Proposed Technical Specification Changes (Markups)

Revised Technical Specification Pages (Clean)

**Limitations and Conditions Compliance for WCAP-18482-NP-A, WCAP-14882-P-A,
WCAP-15306-NP-A, WCAP-15306-NP-A Addendum 2-NP-A, WCAP-17642-NP-A
Revision 1, and WCAP-18240-NP-A**

Figure 2.1.1-1
REACTOR CORE SAFETY LIMIT

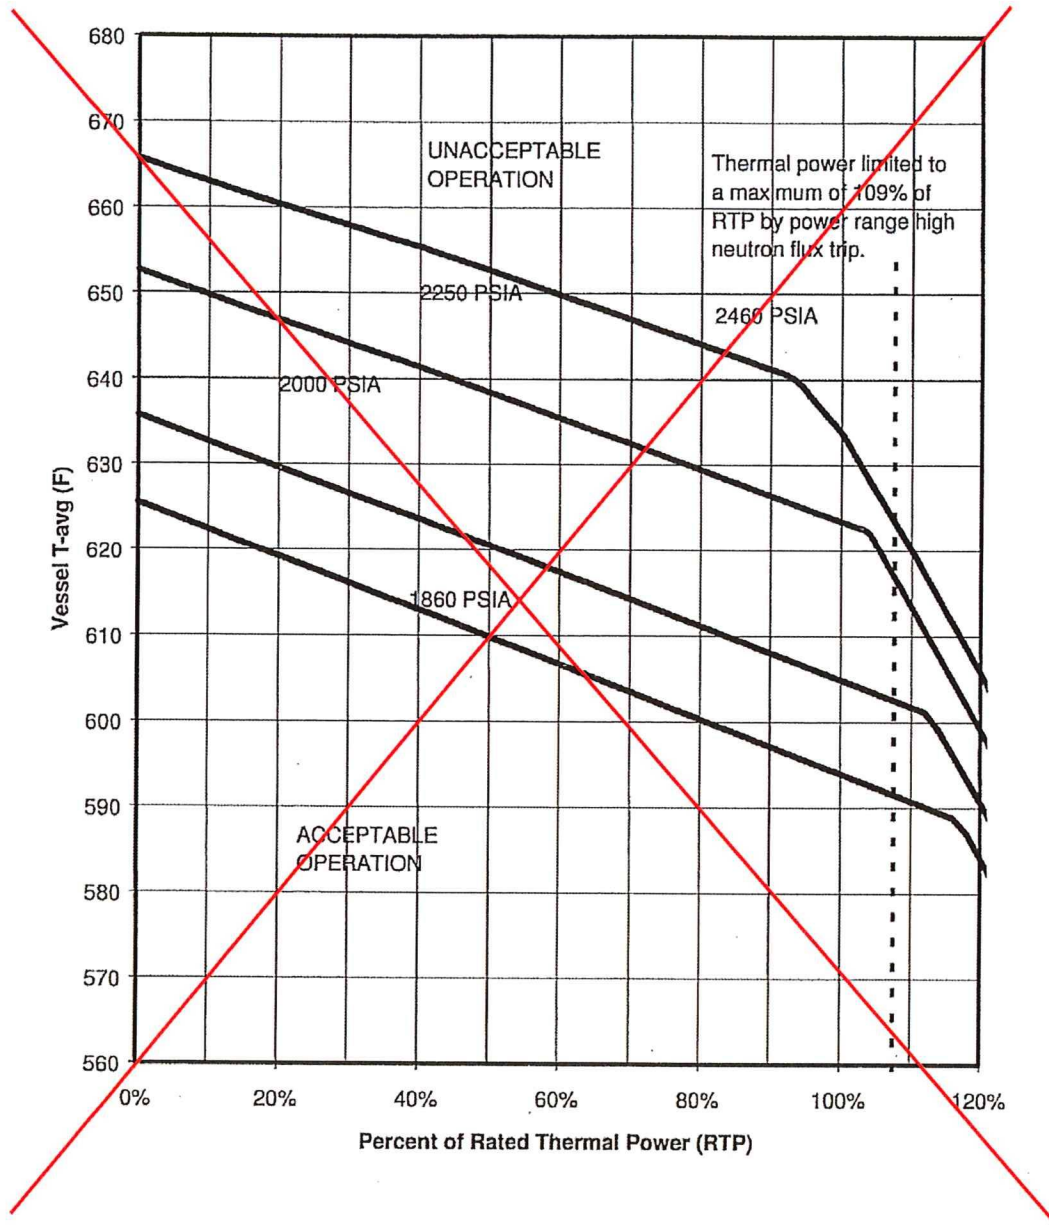
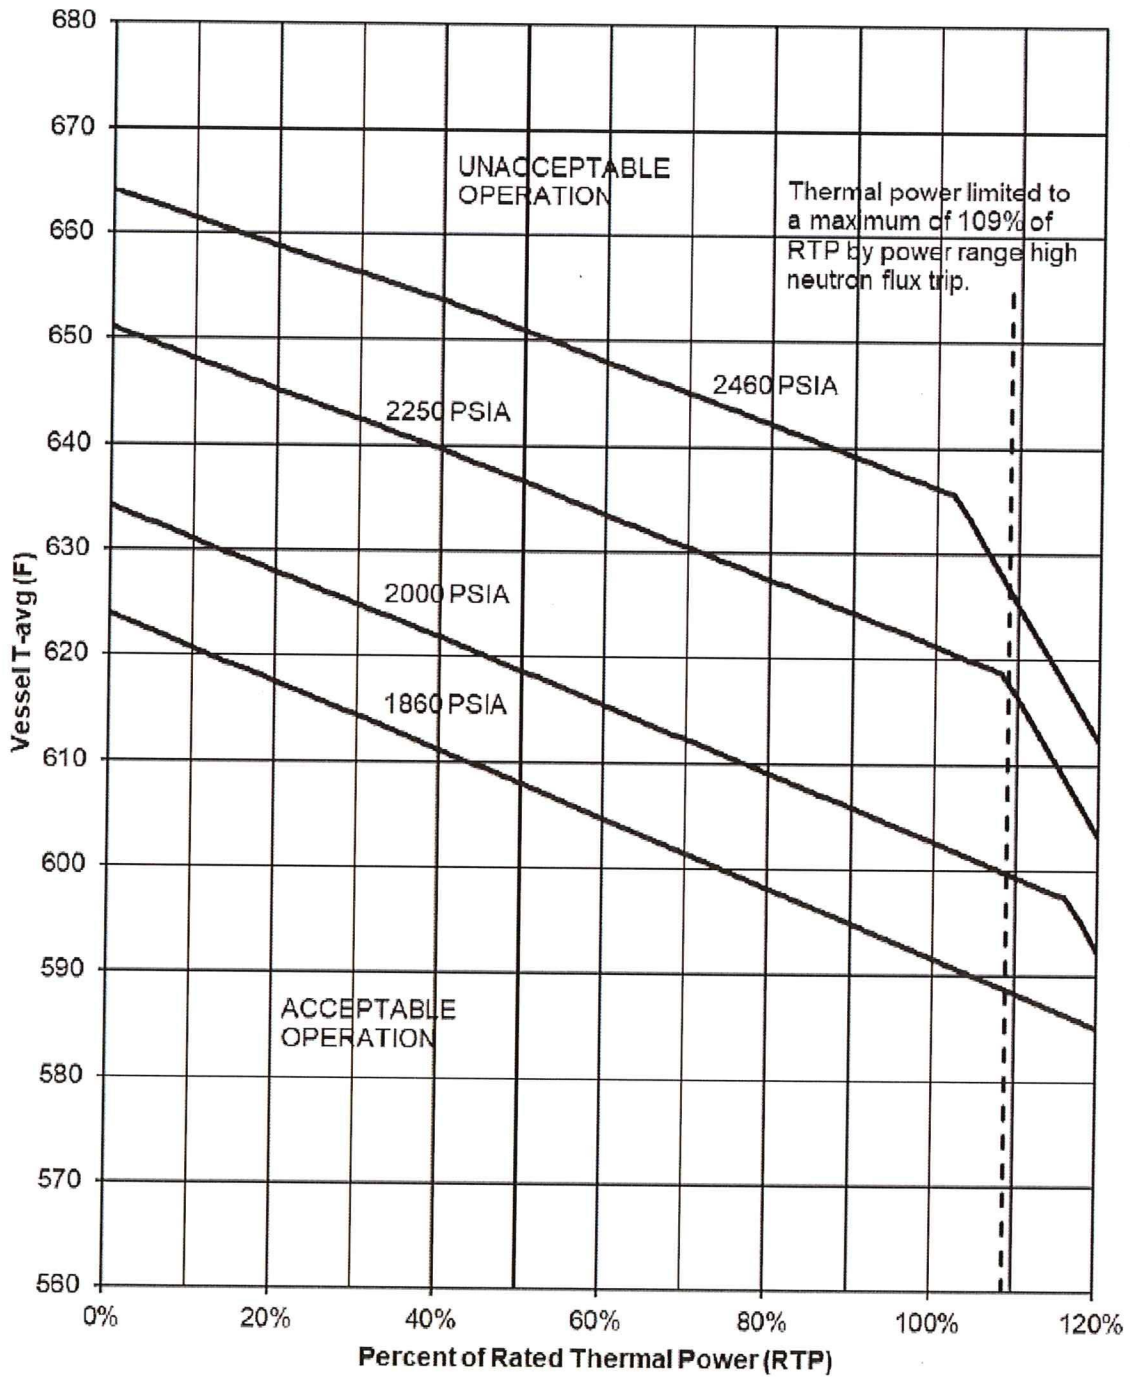
Replace with new Figure 2.1.1-1

Insert new Figure 2.1.1-1
